Service Communication: 2008-003 USA  Designation

Subject: Re-issue of recall campaign 05V-506 – replacing male fuel line fitting:

Specific VINs for the 2001 - 2004 Aprilia RST 1000 Futura
Specific VINs for the 2002 - 2003 Aprilia ETV 1000 Caponord

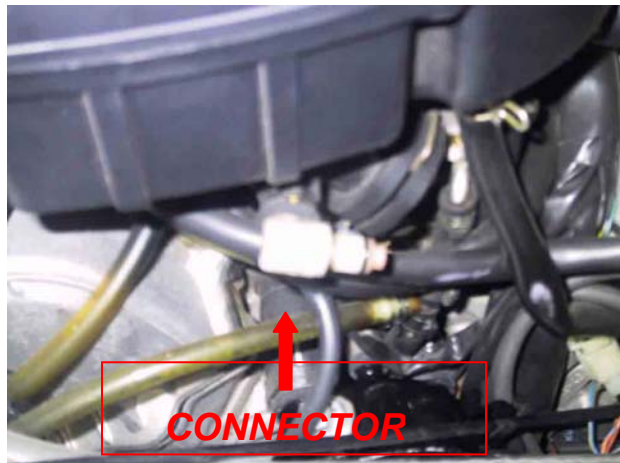
Concern: The male fuel fitting quick connector can break or crack, due to excessive loading when the fuel tank is lifted for service or repairs.

Correction: The male fitting is now of a metal construction. Each example receives one male fitting as part of this recall. The female fitting is not being replaced on either model. The Futura fitting is located on the fuel return hose and the Caponord fitting is located on the pressure side, threaded into the fuel pump plate.

- Replace the old connector with the new brass connector (part # AP8104993)
